P-05-949 SAVE COWBRIDGE OLD GIRLS' SCHOOL FROM DEMOLITION, Correspondence - Petitioner to Committee: additional information, 04.05.20

Cowbridge Intermediate School for Girls

This report comments on the content of the Scourfield Rebuttal, the initial Scourfield Associates Report, and the letter of protest sent in March 2020.

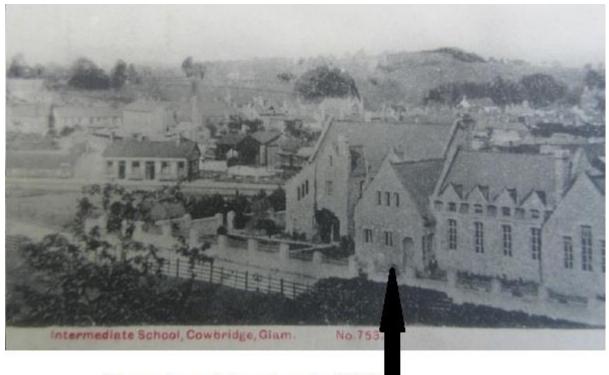
Cadw's main criticism of Scourfield's original Report was that it blurs the distinction between the original school of 1895-6 and the extension of 1909. This was not addressed in the Rebuttal. The interior description in the first Report is vague and relies, in the case of the assembly hall and classroom corridor, on photographs taken in 2017. Furthermore, it is not made clear whether the classroom and corridor belong to the 1895-6 or 1909 phase. Email correspondence with Cadw in 2019 has suggested that the fireplace surrounds in the building have been removed, but the Report specifically cites the fireplaces as part of the surviving fabric. Little detail is provided regarding the plan of the original school, which would be necessary to substantiate the claim that it retains its original plan 'to a very good degree' (although the word 'original' is applied in the Report and Rebuttal to both phases of work). There is evidence that the original plan was changed. A 1907 photograph of the original building shows a projecting gabled bay on the left side of the assembly hall, balancing the classroom wing on the right-hand side. This was replaced by a new two-storey range in the extension of the school in 1909. This is important because it shows that the original

balanced front (it was symmetrical in its mass but not in its fenestration) was lost in the 1909 extension.

this part was taken down in 1909
